AFFIDAVIT OF CORRECTION

To correct certain dimensions of Lots 2 and 4, and Southport Parkway Right-of-way and also Curve 1 in the Center-line Curve Table, Southport East (Lots 1 thru 16 inclusive and Outlot "A"), a subdivision located in the East 1/2 of Section 18, and also in the NW 1/4 of Section 17, all located in Township 14 North, Range 12 East of the 6th P.M., Sarpy County, Nebraska.

AFFIDAVIT OF CORRECTION
 LOTS 2 AND 4, AND SOUTHPORT PARKWAY RIGHT-OF-WAY,
 SOUTHPORT EAST
 (LOTS 1 THRU 16 INCLUSIVE AND OUTLOT "A")
 SARPY COUNTY, NEBRASKA

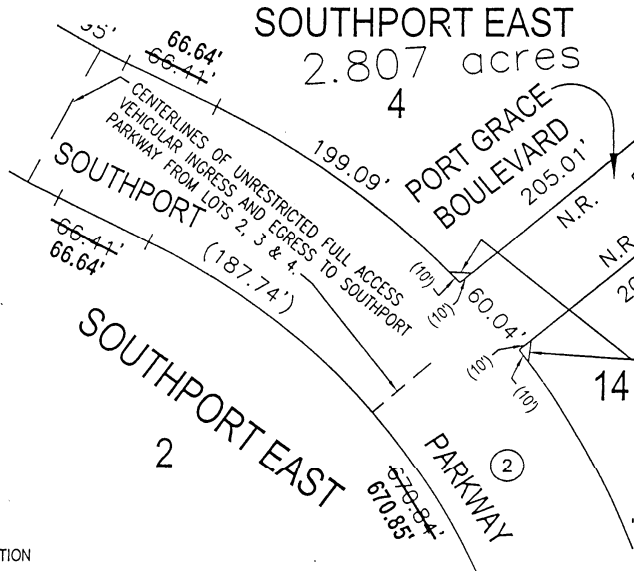
- The Northeastly line of said Lot 2 to read 66.64 feet instead of 66.41 feet.
- The Southwesterly Right-of-way line of Southport Parkway to read 66.64 feet instead of 66.41 feet.
- The Northeastly line of said Lot 2 to read 670.85 feet instead of 670.84 feet.
- The Southwesterly Right-of-way line of said Southport Parkway to read 670.85 feet instead of 670.84 feet.
- The Southwesterly line of said Lot 4 to read 66.64 feet instead of 66.41 feet.
- The Northeastly Right-of-way line of said Southport Parkway to read 66.64 feet instead of 66.41 feet.
- The Curve 1 in said Center-line Curve Table to read Radius - 549.50 feet, Length - 316.08 feet, Tangent - 162.55 feet, Delta - 32°57'26" instead of Radius - 549.32 feet, Length - 316.79 feet, Tangent - 162.39 feet, Delta - 32°56'15".

CURVE 1 549.50' 316.08' 162.55' 32°57'26"
